MONITORING WELL REQUEST AREA OF CONCERN 613 (AOC 613) ZONE F CNC
CHARLESTON SC
6/13/2002
SOUTH CAROLINA DEPARTMENT OF HEALTH AND ENVIRONMENTAL CONTROL

Monitoring Well Request
AOC 613, Zone F
Revision 0, Dated 3 June 2002, Received 5 June 2002

Figure 2-2
 Proposed IM Vertical Profiling Locations
 AOC 613, Zone F
 Charleston Naval Complex

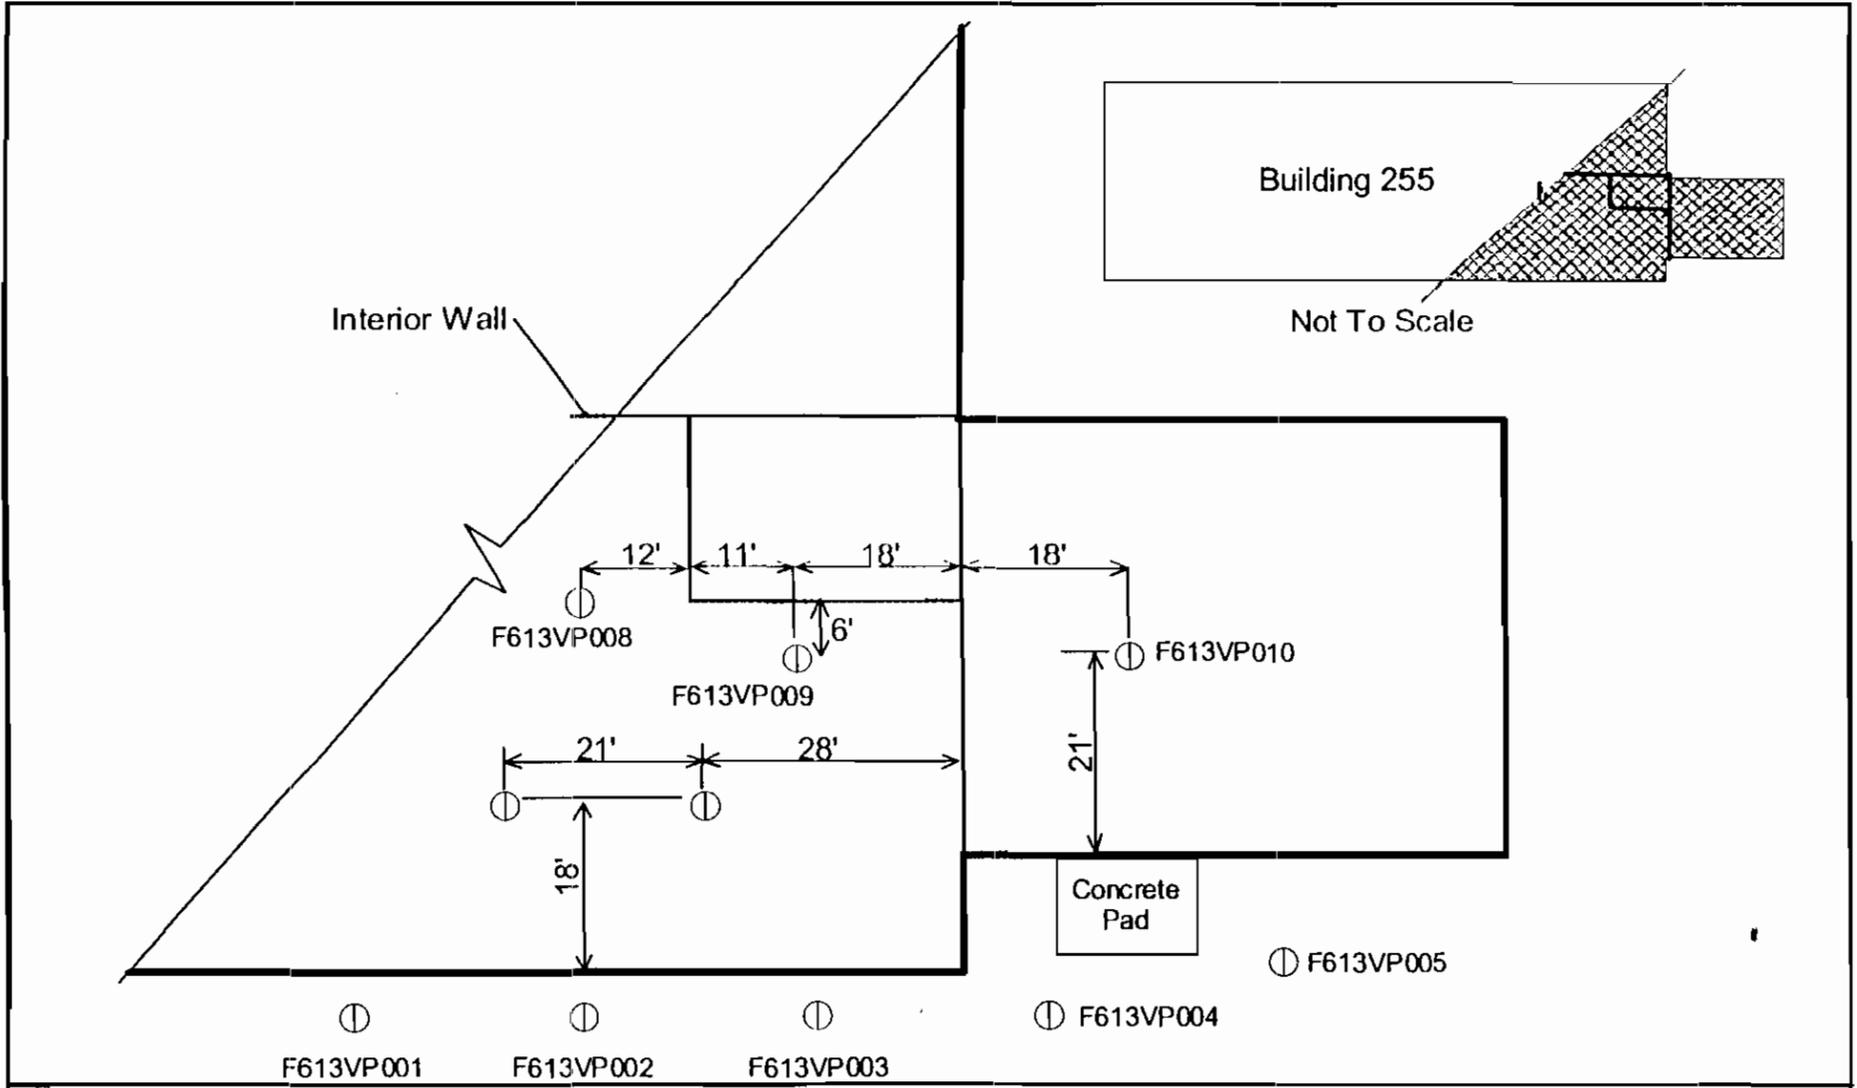
Finally, it is noted that five of the 10 DPT monitoring wells will be installed inside Building 255. Building 255 is currently housing the Confederate submarine Hunley. Given the significance of the activities being undertaken at this building, it is imperative that the Navy remains in close contact with and coordinates with Officials of this historical preservation project.

Attached, please find a copy of the proposed monitoring well locations. A copy of the well approval form and this letter should be on site during drilling operations. Based upon data from these new monitoring wells, additional monitoring wells may be required at this site. Questions regarding this correspondence should be directed to me at 803.896.4016 or by e-mail at bergstpm@dhec.state.sc.us.
